North Transfer Station Stakeholder Group Compendium

Chapter 12: Community Outreach

Executive Summary of Community Outreach, February – May 2011

8/9A Separate Recycling

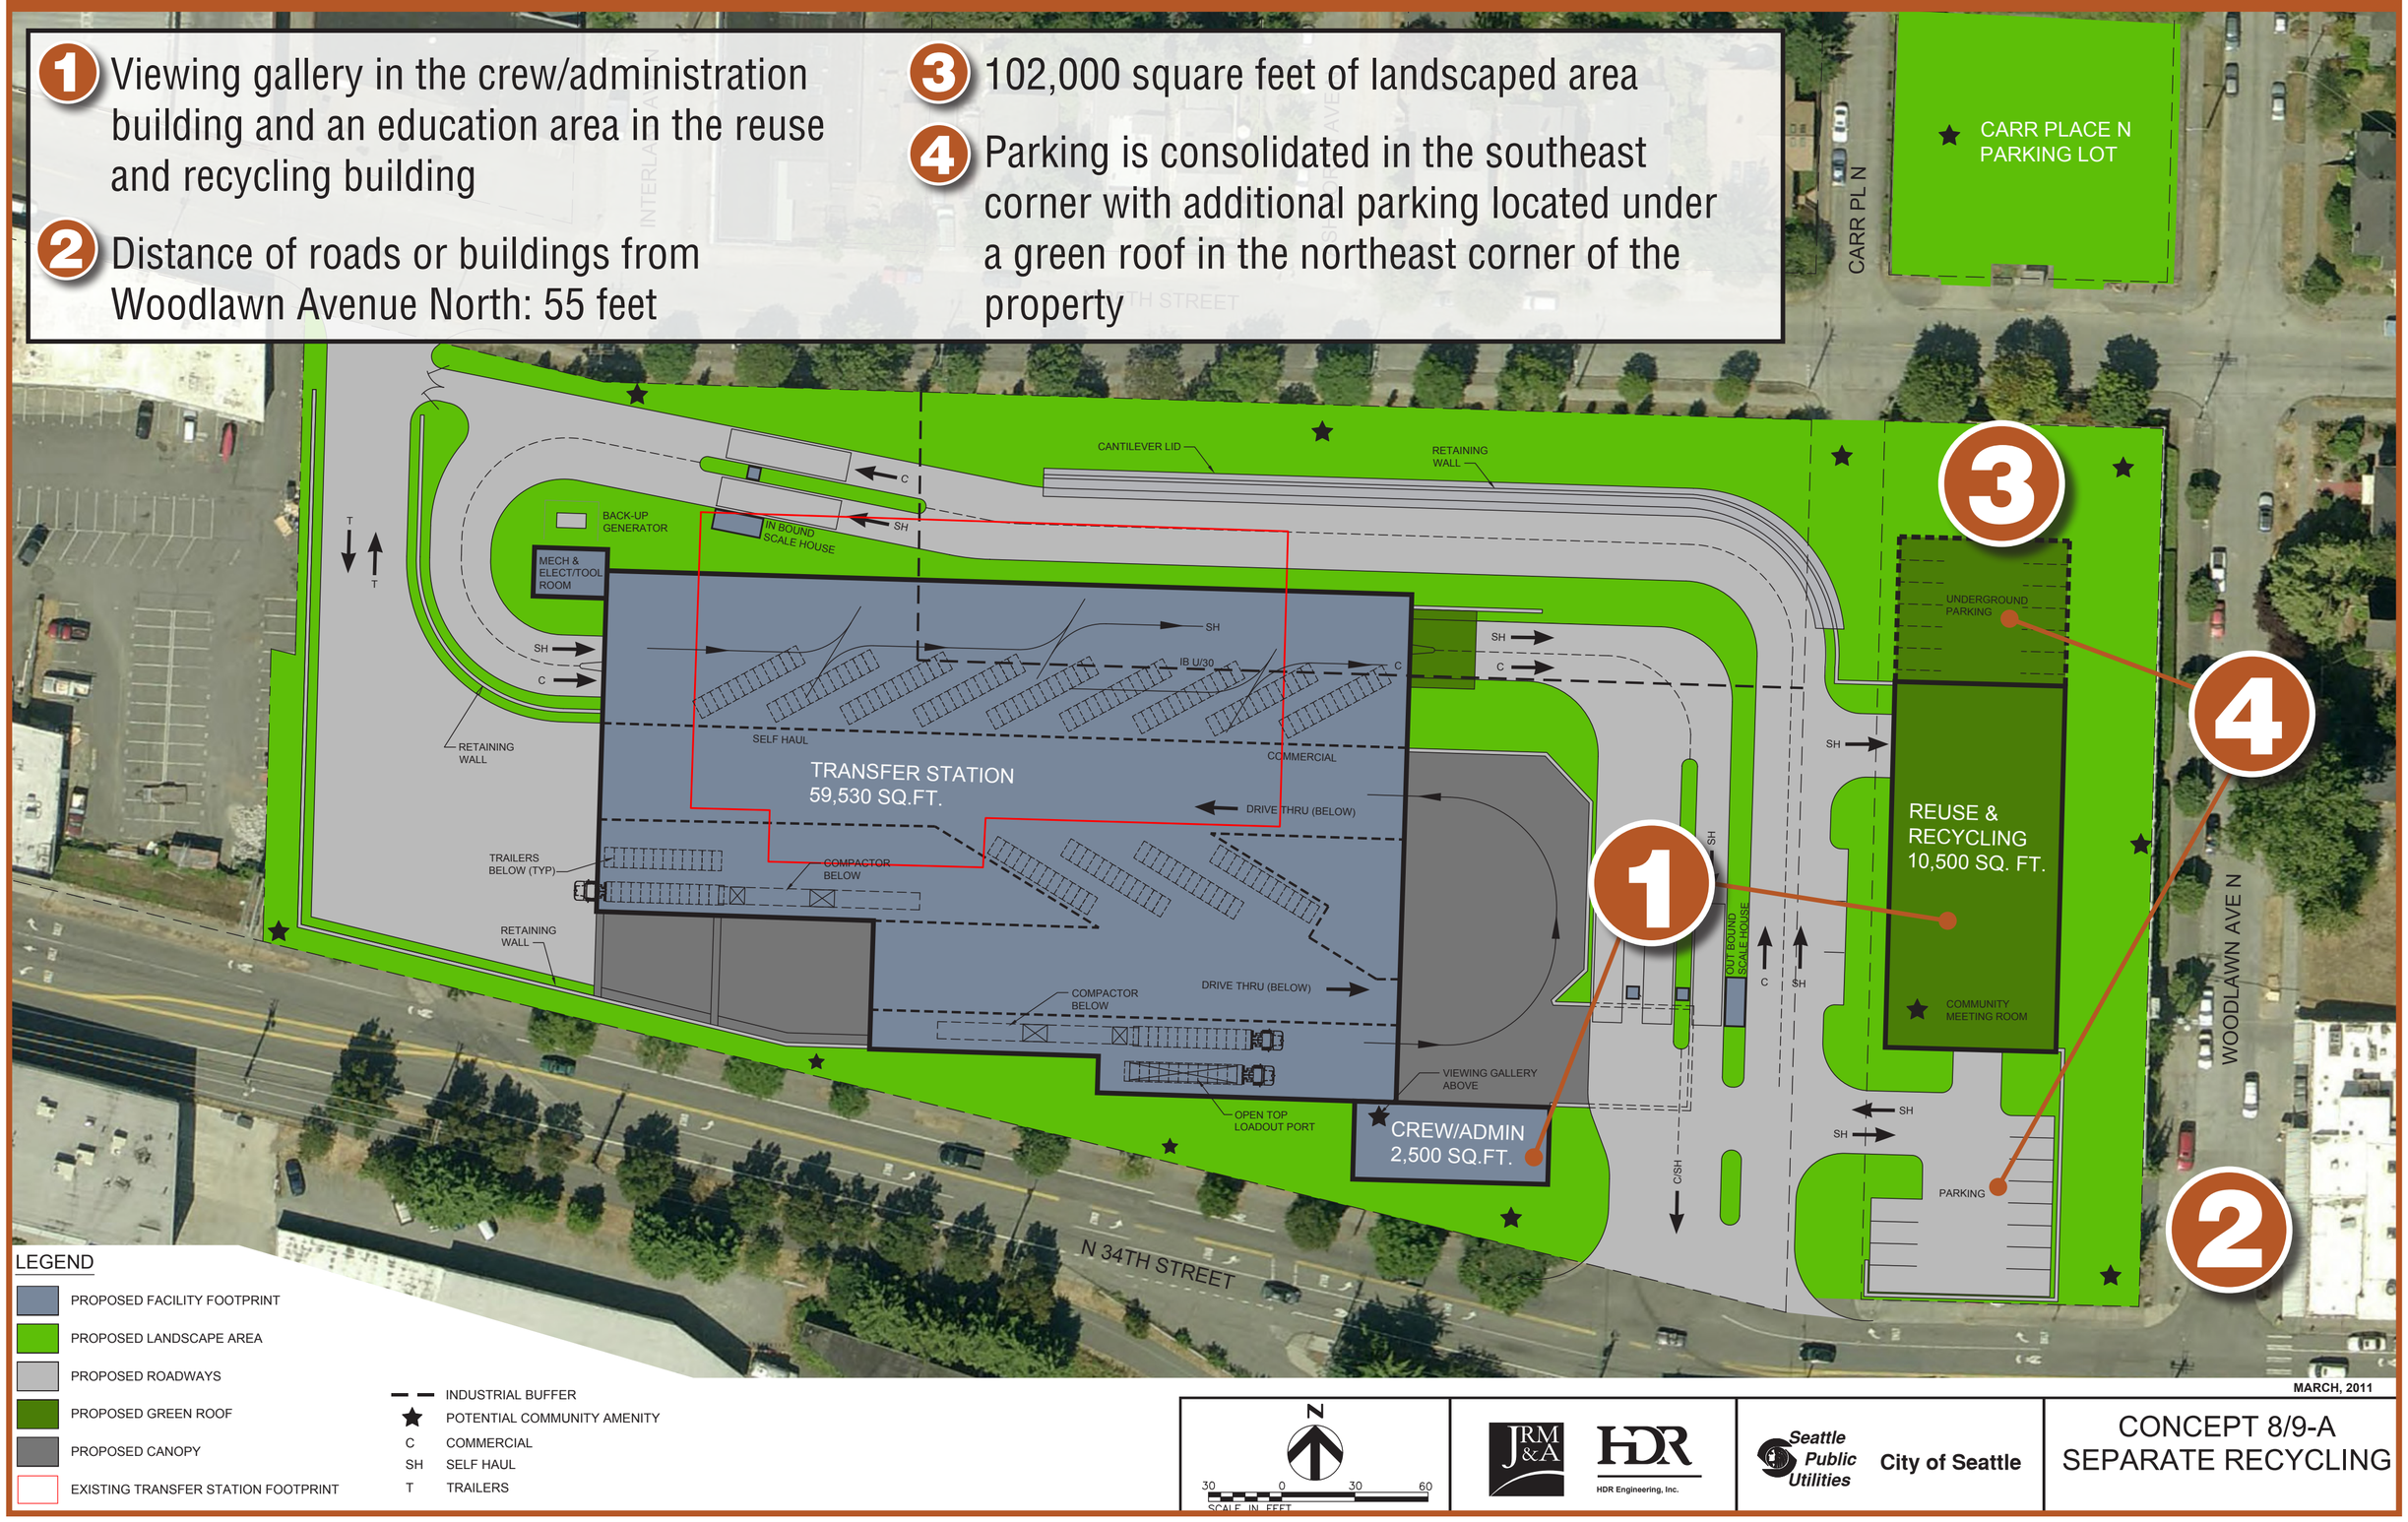
"If there is a separation of the reuse and recycling building, visitors may not be inclined to make both loops. Also, not having it all in one facility may make it more difficult to retrofit in the future as Seattle moves toward zero-waste."

8/9B Attached Recycling

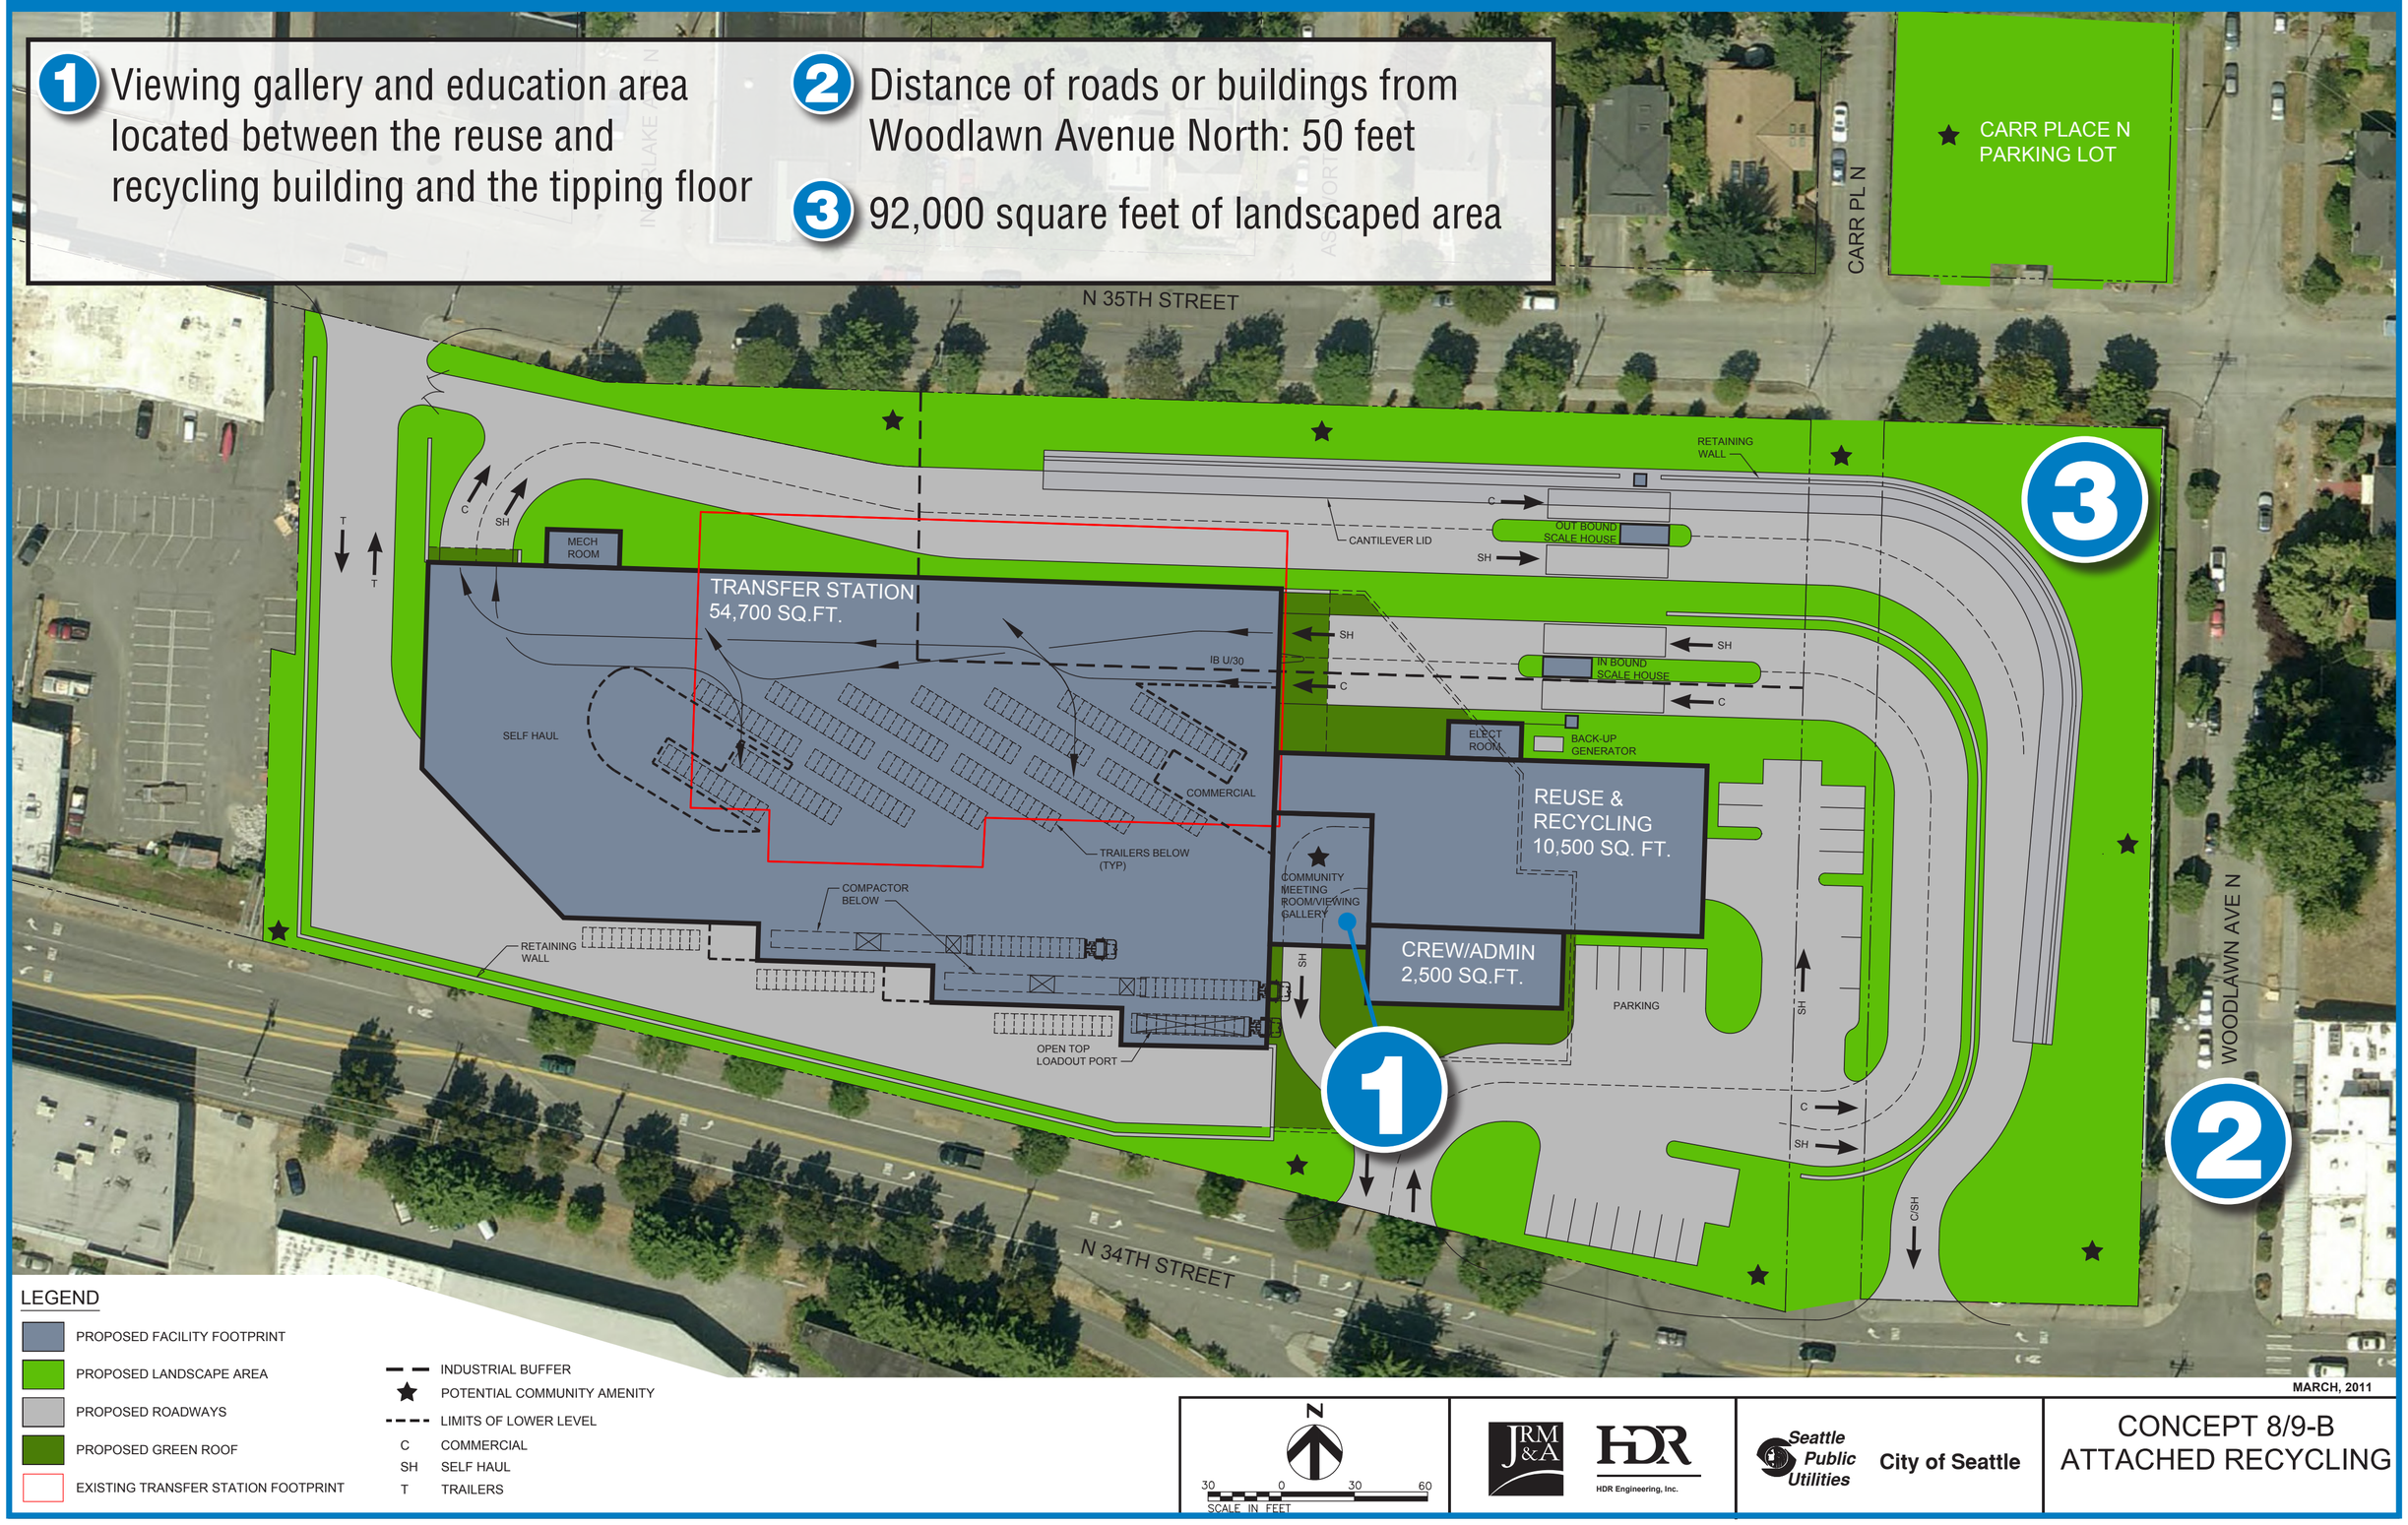
4 Concepts require rezones and/or land use changes and extend beyond the 1350 parcel to also develop Carr Place, the 1550 parcel and the Carr Place Parking lot. Of those 4 concepts, the opinion of the WCC is that Concept 8/9B-Attached Recycling best addresses our concerns. The option:

- Sites the Transfer Station further south and no further east than the existing station and locates the Reuse and Recycling Facility next to the transfer station on the 1350 parcel.
- Offers the greatest separation between the adjacent residential neighborhood and NTS buildings and their internal operations.
- Caps the internal operations of the Transfer Station by stacking the customer entrance and recycling facility over the transfer trailer traffic to reduce noise, odor and pollution exiting the facility.
- Creates a cantilevered lid to redirect noise from the drive lanes.
- Maintains a significant landscaping area along N 35th and Woodlawn Avenue N.
- Provides Carr Place Parking Lot as a Community Amenity.

ALTERNATIVE NO REZONE CONCEPT

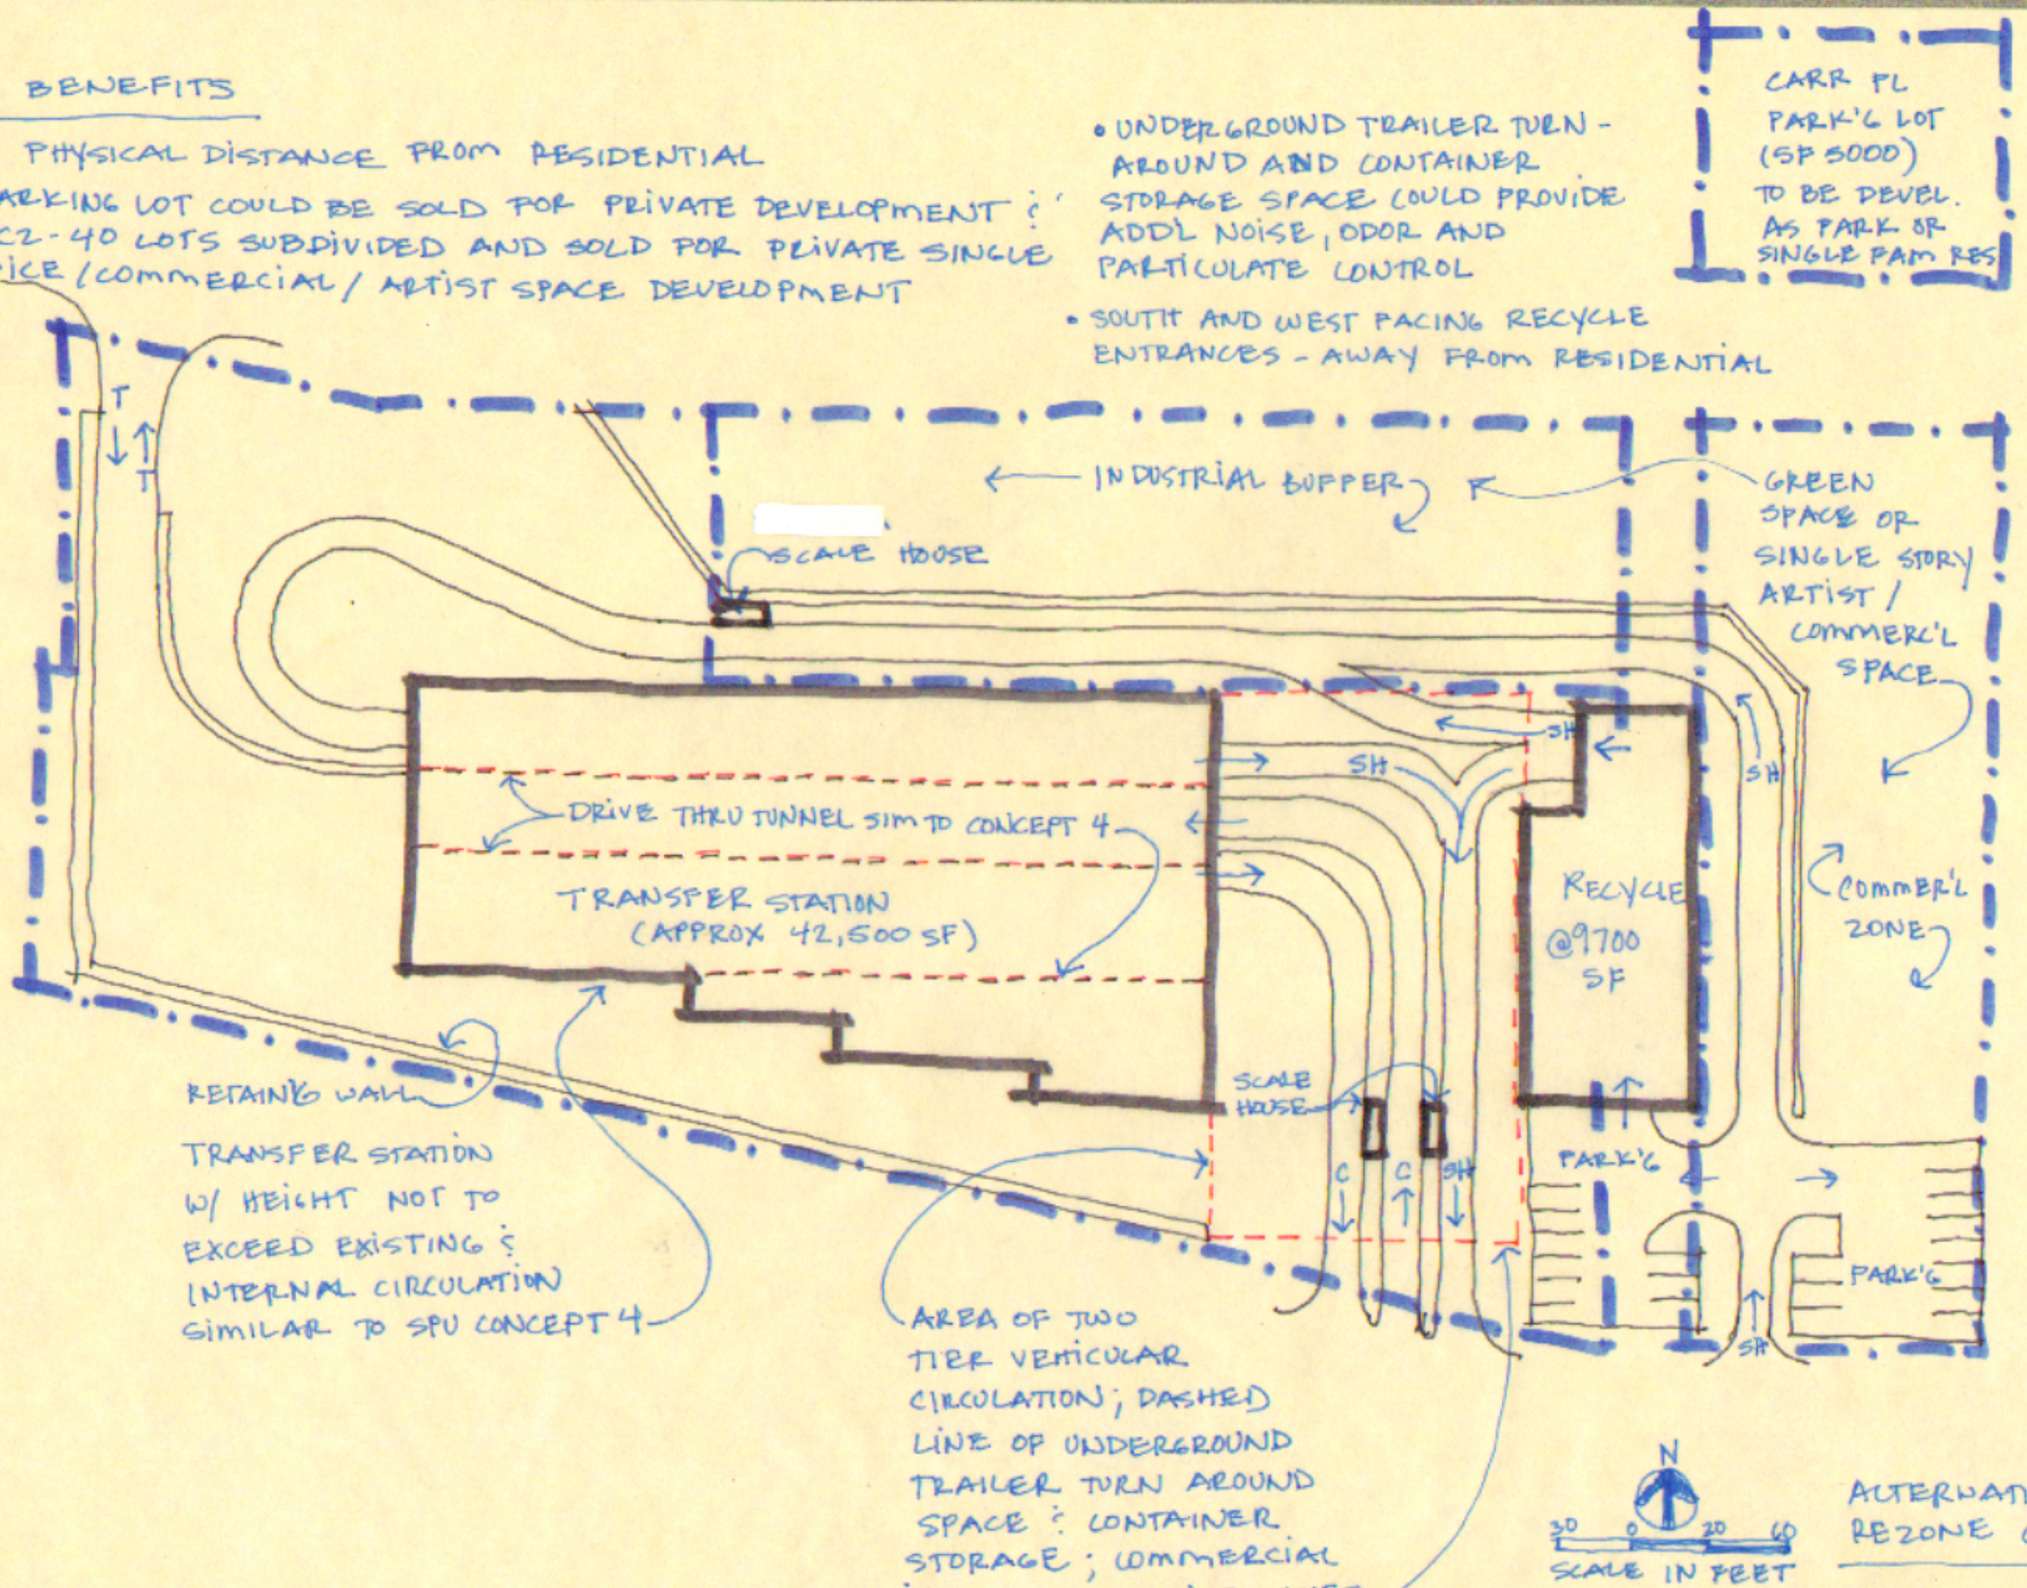
- MAINTAINS PHYSICAL DISTANCE FROM RESIDENTIAL
- CARR PL PARKING LOT COULD BE SOLD FOR PRIVATE DEVELOPMENT ? IB U/30 ; C2-40 LOTS SUBDIVIDED AND SOLD FOR PRIVATE SINGLE STORY OFFICE / COMMERCIAL / ARTIST SPACE DEVELOPMENT
- UNDERGROUND TRAILER TURN-AROUND AND CONTAINER STORAGE SPACE COULD PROVIDE ADD'L NOISE, ODOR AND PARTICULATE CONTROL
- SOUTH AND WEST FACING RECYCLE ENTRANCES - AWAY FROM RESIDENTIAL
